Access Compliance Report

Public Rights-of-Way

(Curb Ramps)

Intersection ID: 54779	Main Street: SHARON AMITY RD	Cross Street: CHARLESTON DR	Location: SE
ADA ID: 987488F85288	Ramp Type: Perp	Initial Pass/Fail: Fail	Overall Compliance: No
Codes/Mitigation Info/Possible Solution			Severity Score: 25
			Field Measurements/Component Compliance

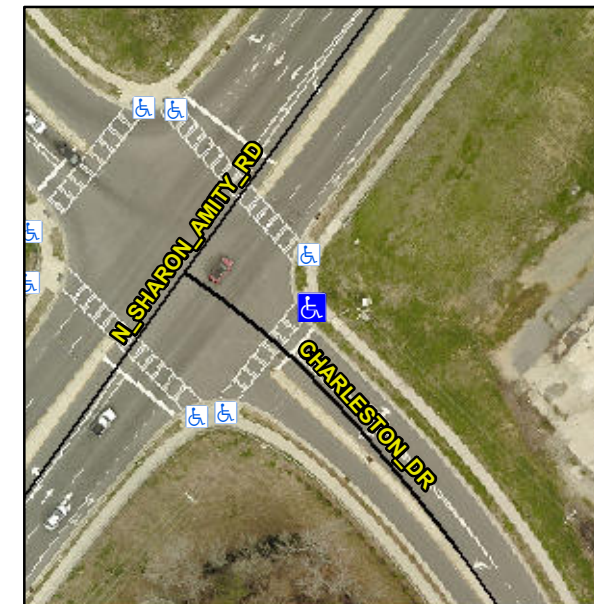
R304.2.2, R304.5.3

Compliance	Description	Data	Compliance	Description	Data
N/A	Ramp Length (in)	66.0	No	Ramp Slope (%)	8.8
Yes	Ramp Width (in)	59.0	No	Ramp XSlope (%)	5.7
N/A	Flare Type LT	N/A	N/A	Flare Type RT	N/A
N/A	Flare Slope LT (%)	N/A	N/A	Flare Slope RT (%)	N/A
N/A	Flare Traversable LT?	N/A	N/A	Flare Traversable RT?	N/A
N/A	Landing Length (in)	N/A	N/A	DWS Provided?	N/A
N/A	Landing Width (in)	N/A	N/A	DWS Contrast?	N/A
N/A	Landing Slope (%)	N/A	N/A	DWS Length (in)	N/A
N/A	Landing X Slope (%)	N/A	N/A	DWS Full Width?	N/A
N/A	Landing Curb? (Y/N)	N/A	N/A	DWS Offset (in)	N/A
N/A	Shared Landing?	N/A			
N/A	Gutter Ponding?	N/A	N/A	Gutter Slope (%)	N/A
N/A	Gutter Lip Ht (in)	N/A	N/A	Gutter X Slope (%)	N/A
N/A	Painted X Walk1?	Yes	N/A	Painted X Walk2?	N/A
	X Walk 1 Direction	To SW		X Walk 2 Direction	N/A
N/A	X Walk 1 Width (in)	103.0	N/A	X Walk 2 Width (in)	N/A
	X Walk 1 Slope (%)	3.4		X Walk 2 Slope (%)	N/A
	X Walk 1 X Slope (%)	4.3		X Walk 2 X Slope (%)	N/A

Remove & Replace Entire Ramp.
